465

MOD XB

MODIFICATION INSERT

465 MOD XB

PARTIAL POWER SUPPLY

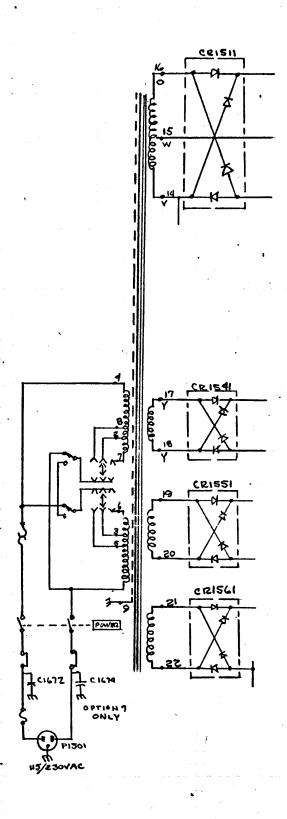
This manual insert describes the special features of MOD XB as it applies to the Tektronix 465 Oscilloscope. MOD XB deletes the 12/24 V auxiliary transformer winding (terminals 10 through 12).

MOD XB is not compatible with field or factory installation of Option 7 (DC Operation), DM40-Series Digital Multimeters, or the MOD UA Transition Counter without first replacing the AC Power Transformer.
